TITLE				SPEED CONTROL HEAT SENSITIVITY		PIB NO. DK-3002							
PRODUCT LINE	TAPE DISK FORMATTER	<input type="checkbox"/>	EQUIPMENT CHANGED SERVO PCBA 102811-xx	MODEL SERIES AFFECTED D-3000	EFFECTIVE DATE 3-27-74								
CLASS OF BULLETIN:			ORDER PART KIT NO.	EFFECTIVITY									
<input checked="" type="checkbox"/> IMPROVEMENT <input type="checkbox"/> RETROFIT ON FAILURE <input type="checkbox"/> RETROFIT RECOMMENDED <input type="checkbox"/> INFORMATION ONLY <input type="checkbox"/> _____			N/A	ALL SERVO PCBA'S LOWER THAN V REVISION SHOULD BE CHECKED.									
<p>SUBJECT: Speed Control Heat Sensitivity</p> <p>PURPOSE: All D3000 disk drives have an emergency unload circuit that monitors key areas of the drive for proper operation. Should this circuit be unloading a particular drive intermittently, speed errors (LDSEG) could possibly be the problem. Improvements have been facilitated to the servo board that will reduce the heat sensitivity of the motor speed control circuit. By the incorporation of this change, a previously shipped D3000 can be updated to current shipping configurations.</p> <p>SYMPTOMS OF INTERMITTENT SPEED ERRORS:</p> <ul style="list-style-type: none"> • Unexplaina

FIG. 1

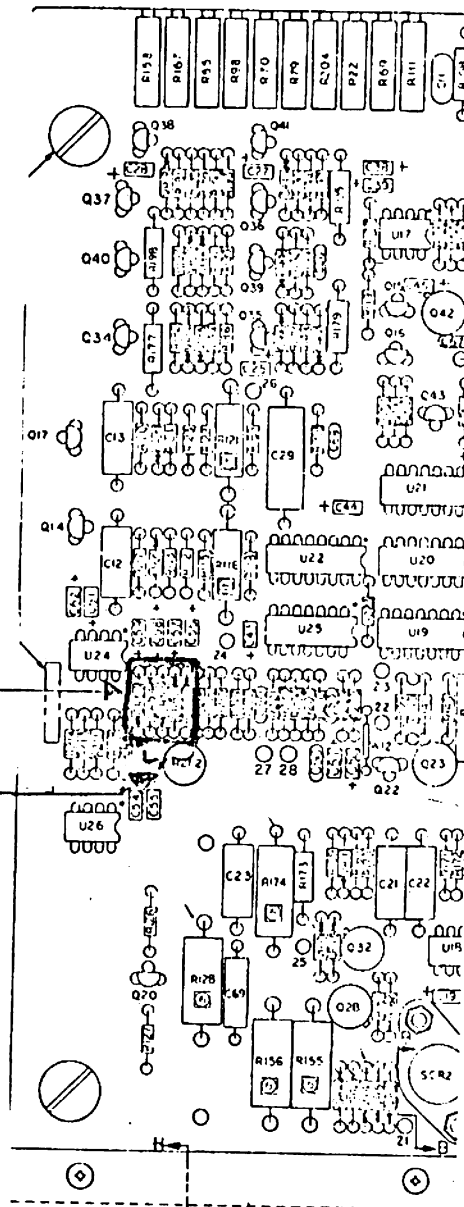
REPLACE CR55 WITH
3.3V ZENER

CLIP OUT CR51, 52,
53 and 54

DIODE ORIENTATION
